Safety Notice

Safety notice frontcontainer DROP - regarding all sizes

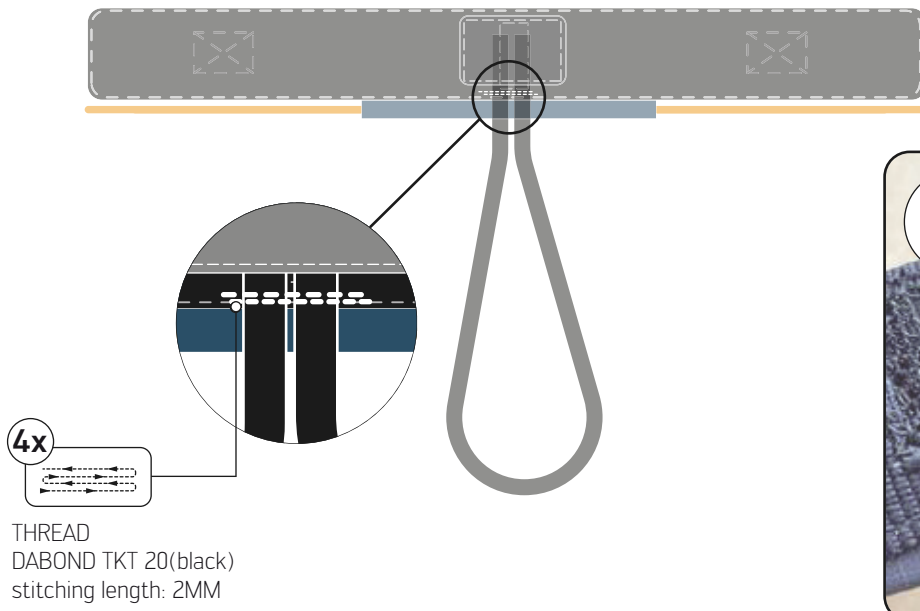
During our regular quality control, it was found on the DROP frontcontainer that the connection line leading to the rescue handle did not have the required seam strength. Our internal limit is 70DaN, which was undershot during quality control.

Experience has shown that the lower strength of the seam in connection with the construction excludes tearing off during the opening process, but we as the manufacturer feel responsible for publishing this incident and taking further measures:

In order to rule out any safety risk, the DROP frontcontainer may only be used again after an additional fixing seam has been attached.

This seam can be applied at a skywalk authorized check center or skywalk directly. Please contact your dealer or importer for a quick revision. Alternatively, we can send you a revised rescue handle within the next two weeks.

BACKSIDE BEFORE

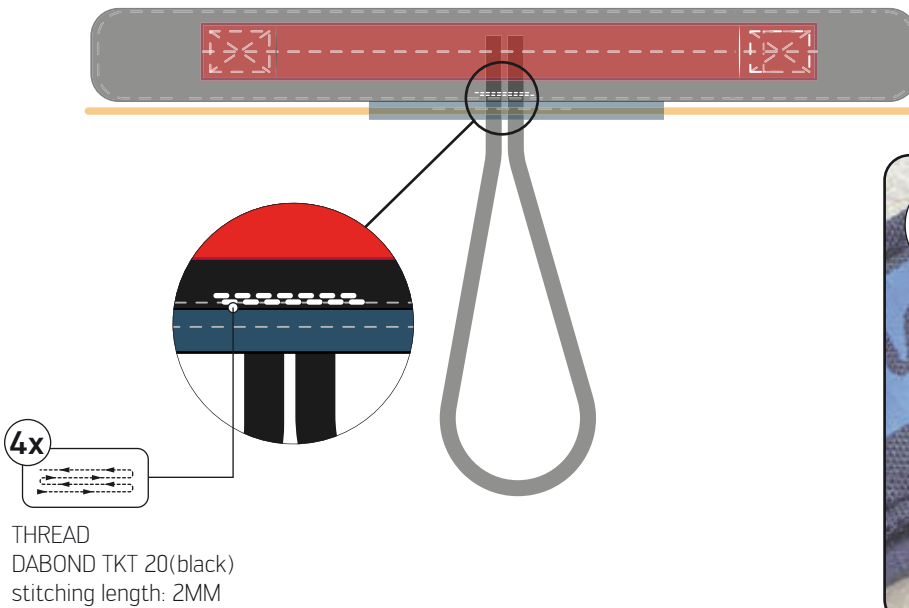
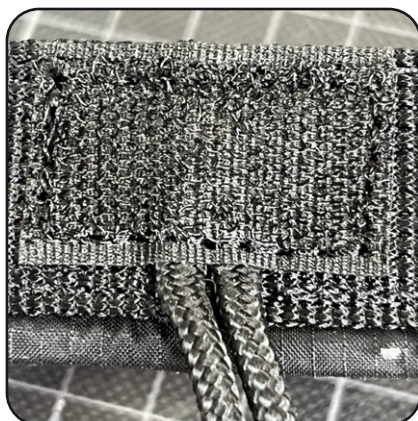
without Rework

BACKSIDE AFTERWARDS

with Rework
